Access Compliance Report

(Curb Ramps)

| Intersection ID: 47108 | Main Street: FRANK_LITTLE_CT | Cross Street: ERNEST_RUSSELL_CT | Location: SE |
| ADA ID: 6A6E11B1AFE4 | Ramp Type: PerpDiag | Initial Pass/Fail: Fail | Overall Compliance: No |

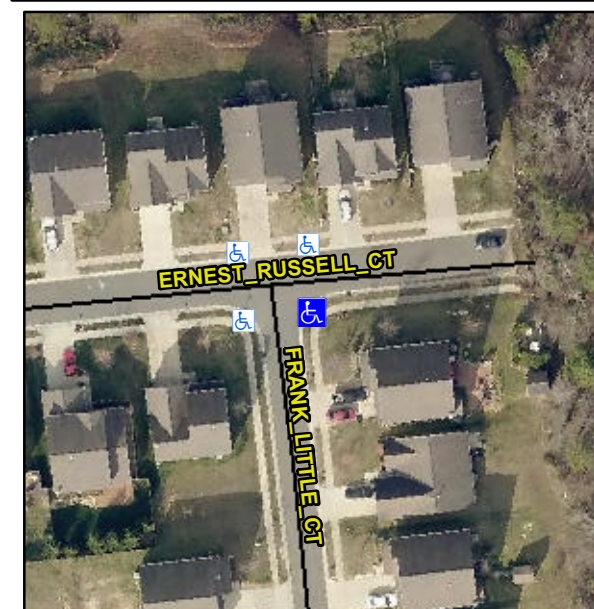
Not Found, R304.5.1, R304.2.2, R304.5.3

| Compliance | Description | Data | Compliance | Description | Data |
|------------|-----------------------|------|------------|-----------------------------|------|
| N/A | Ramp Length (in) | 55.0 | No | Ramp Slope (%) | 11.0 |
| No | Ramp Width (in) | 36.0 | No | Ramp XSlope (%) | 8.3 |

Remove & Replace Curb Ramp With Two New Directional Ramps or Equivalent.
